067R9608

Thermostatic expansion valves TE 5, TE 12, TE 20, TE 55

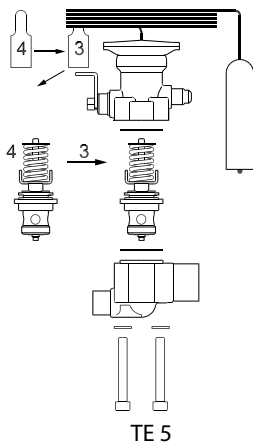
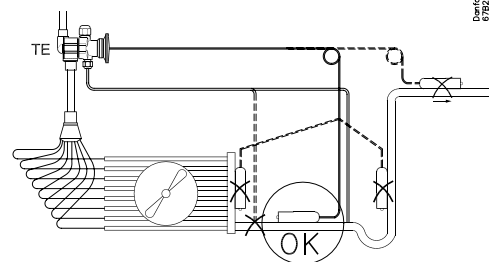
Combining previous and new orifices and elements, please control the superheat in the system.
New orifices - code no. 067B27** and 067G27**. New elements marked with "MWP 28 bar" on box.

Old orifice			New orifice			Nominal capacity TR/kW								Factory settings Y-value
Type	Orifice No.	Old code	Type	New Code	Orifice no.	R134a	kW	TR	kW	TR	kW	TR	kW	
TE5	1	067B2089	TE5	067B2788	0,5	2	7,0	2,5	8,7	3	10,8	3	11,1	26
	2	067B2090		067B2789	1	3,5	12,0	4	14,6	5	18,3	5,5	18,8	26
	3	067B2091		067B2790	2	5	16,9	6	20,1	7,5	25,6	7,5	26,1	26
	4	067B2092		067B2791	3	6	21,7	7,5	26,3	9,5	33,0	10	33,9	26
TE12	1	067B2005 ¹⁾	TE12	067B2792	4	8,5	29,0	10	34,6	12,5	43,9	13	44,8	26
	2	067B2006 ¹⁾		067B2790 ¹⁾	2	5	16,9	6	20,1	7,5	25,6	7,5	26,1	26
	3	067B2007 ¹⁾		067B2791 ¹⁾	3	6	21,7	7,5	26,3	9,5	33,0	10	33,9	26
	4	067B2008		067B2792 ¹⁾	4	8,5	29,0	10	34,6	12,5	43,9	13	44,8	26
TE20	1	067B2172	TE20	067B2708	5	11	39,0	14,5	50,6	17	58,8	17	60,0	37
	1	067B2170		067B2709	6	13,5	47,5	17,5	61,0	20,5	71,2	21	72,7	37
	1	067B2175		067B2710	7	16	55,8	20	70,6	23,5	81,4	24	84,5	37
				067B2711	8	20	69,5	22	77,6	29,5	104,0	32,5	113,0	31
